FINAL PLAT **SWBC Rockwall Addition, Phase 1** Lots 1, Block A 21.280 Acres

AGENDA ITEM: P2018-033; Final Plat: SWBC Rockwall Addition, Phase 1

Project Number P2018-033

Project Name Lot 1, Block A, SWBC Rockwall Addition,

17193

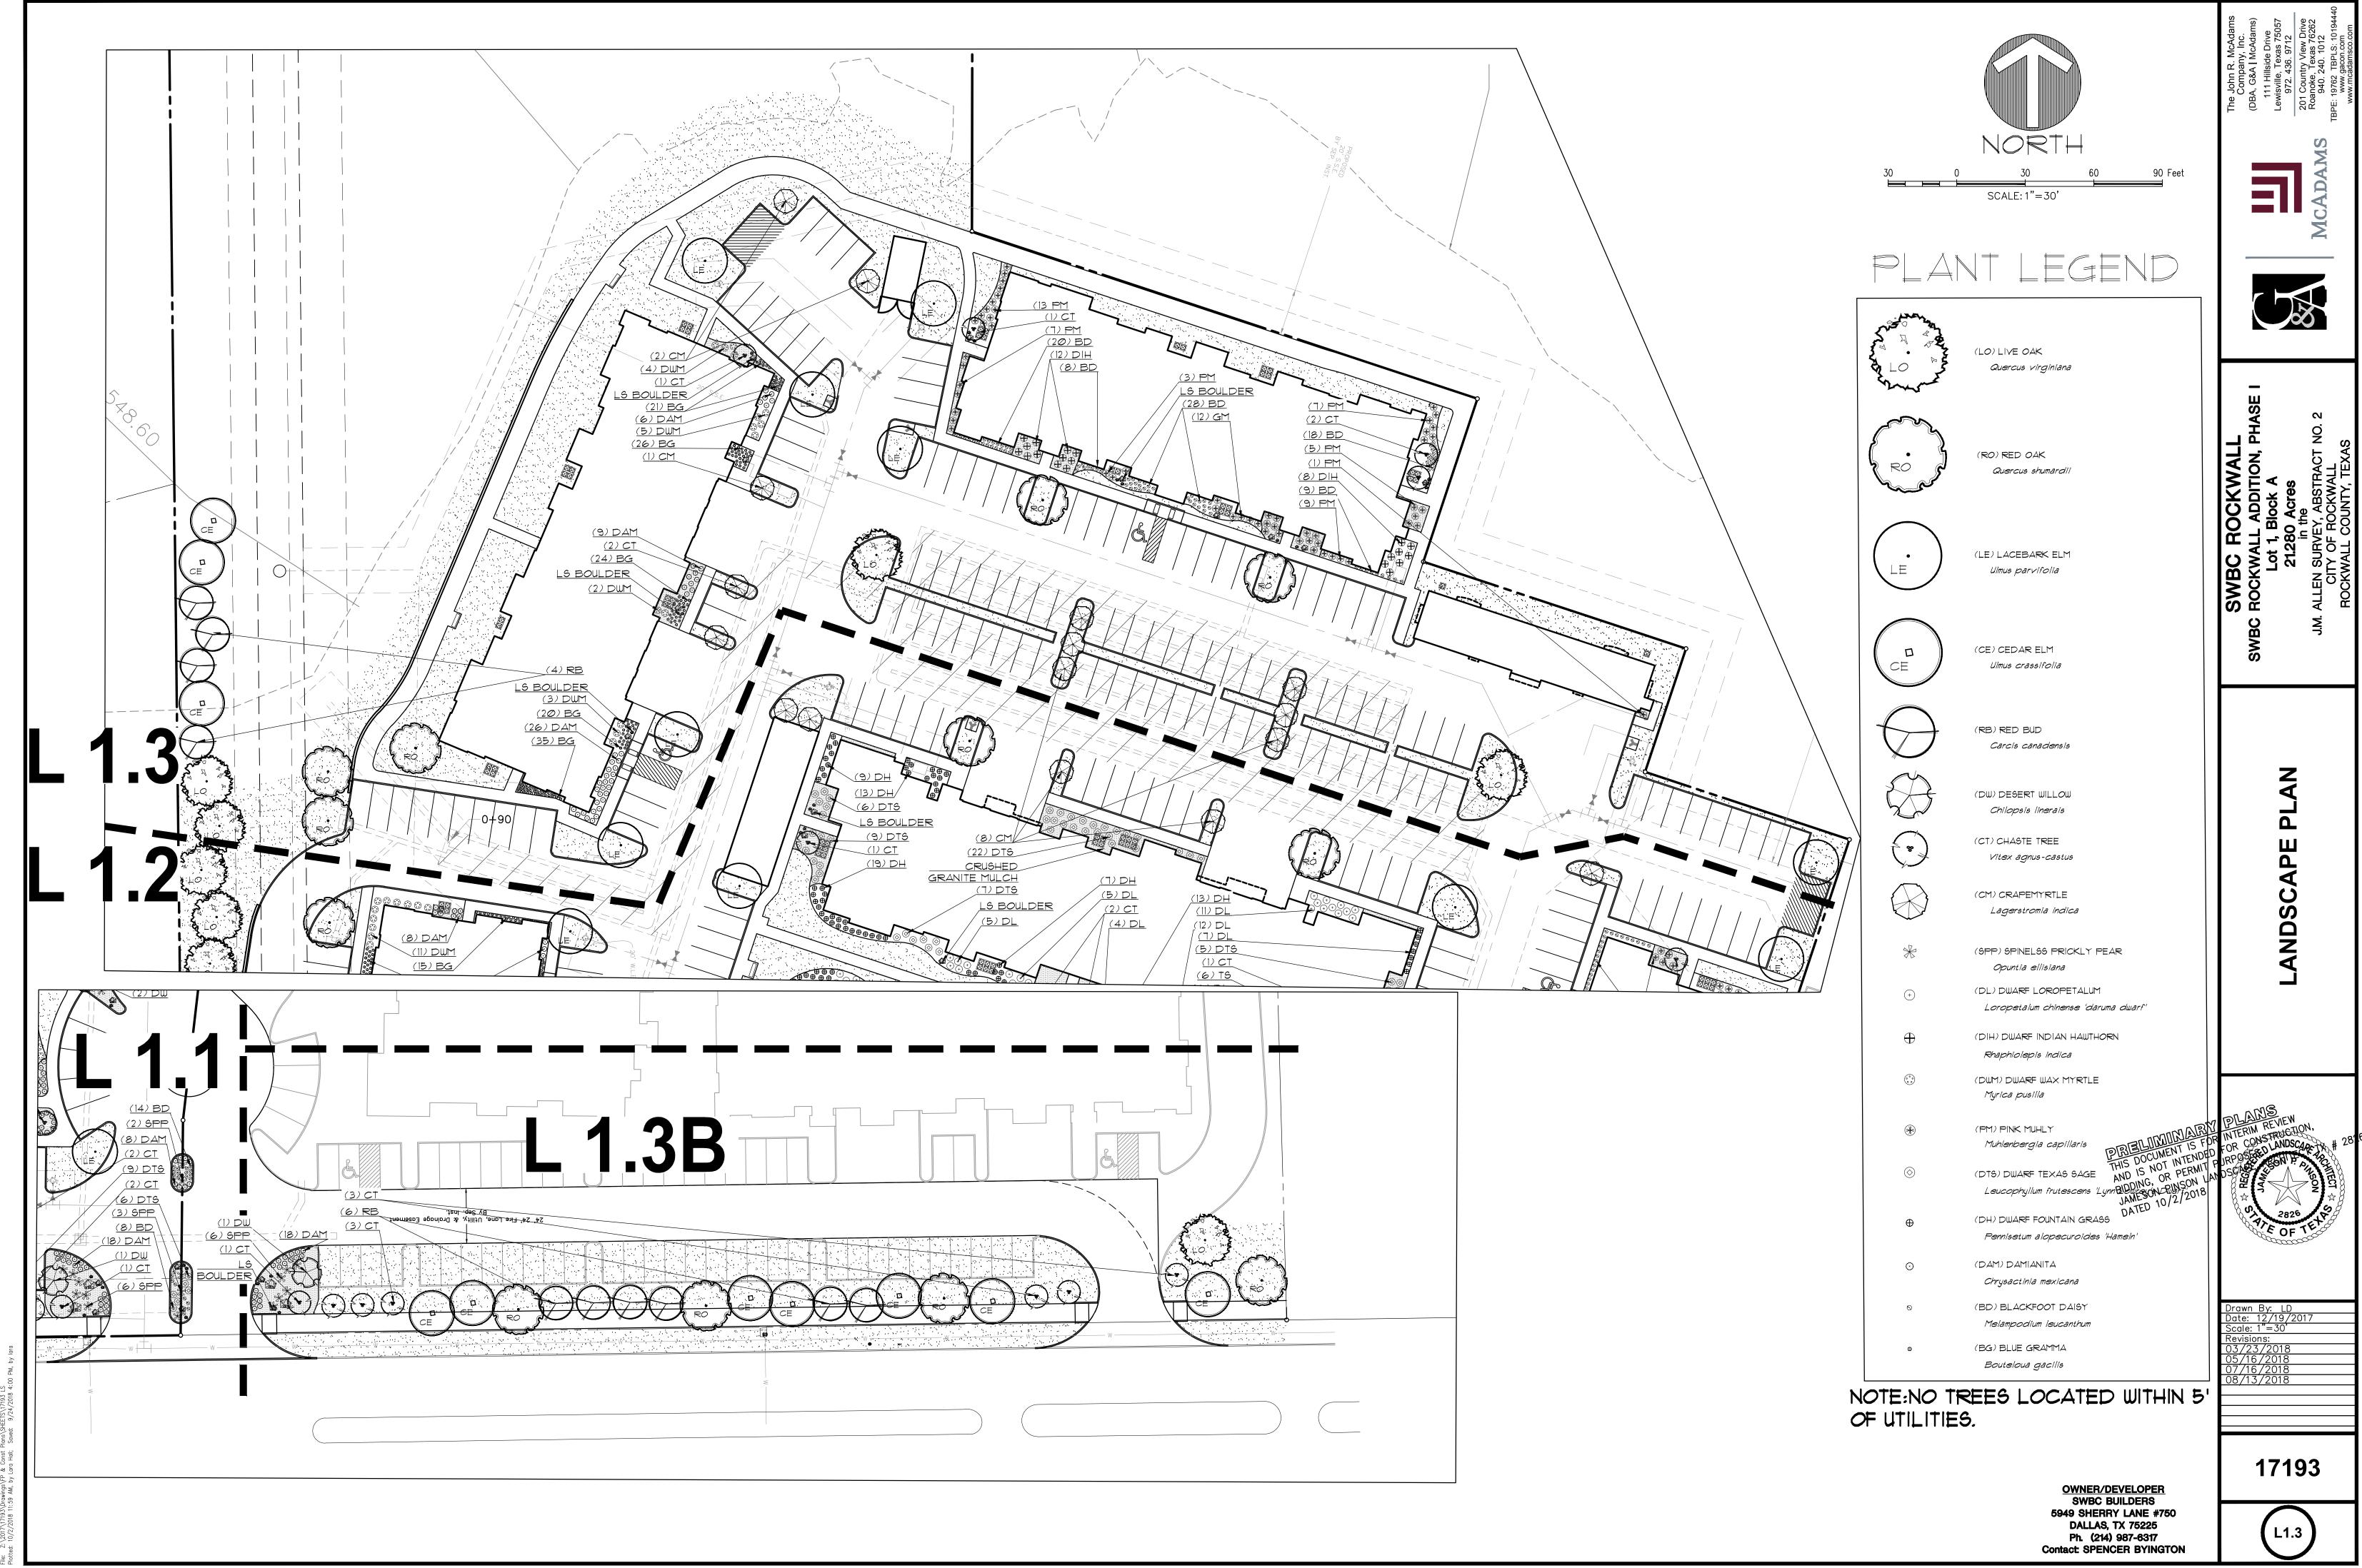
- Add note: No trees within 5' of public utilities.
- Many trees were marked up for being too close to the utilities.

LANDSCAPE TREES SHALL NOT BE PLANTED WITHIN 5' OF ANY PUBLIC UTILITIES.
